# Groundwater Transfer Review Summary Form

Transfer/PA # T- 14804 (RA)

Application: T-14804

Applicant Name: Molalla Poultry, Inc.

Well Location Map

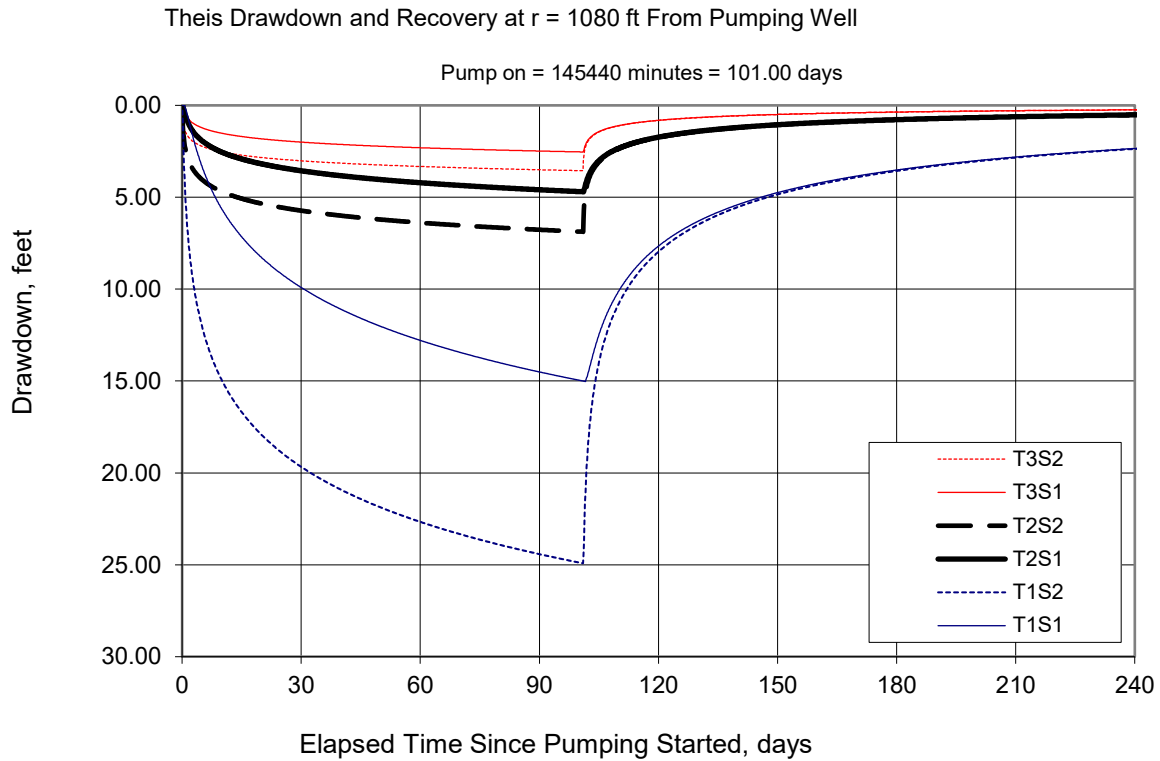
5. a) Will this proposed change, at its maximum allowed rate of use, likely result in an increase in interference with **another ground water right**?  
 Yes  No Comments: “Proposed Well 2” is ~1,080 ft east of neighboring well MARI 341, sole authorized POA on Cert 53064. The authorized POA (MARI 605) is 3,540 ft south of MARI 341. The reduced intervening distance will likely increase interference with MARI 341.

6. a) Will this proposed change, at its maximum allowed rate of use, likely result in an increase in interference with **another surface water source**?  
 Yes  No Comments: Ryan Creek is ~420 ft southeast of “Proposed Well 1” and ~1,380 ft east of the authorized POA (MARI 605). The closer proximity of “Proposed Well 1” to Ryan Creek will likely increase interference with Ryan Creek.
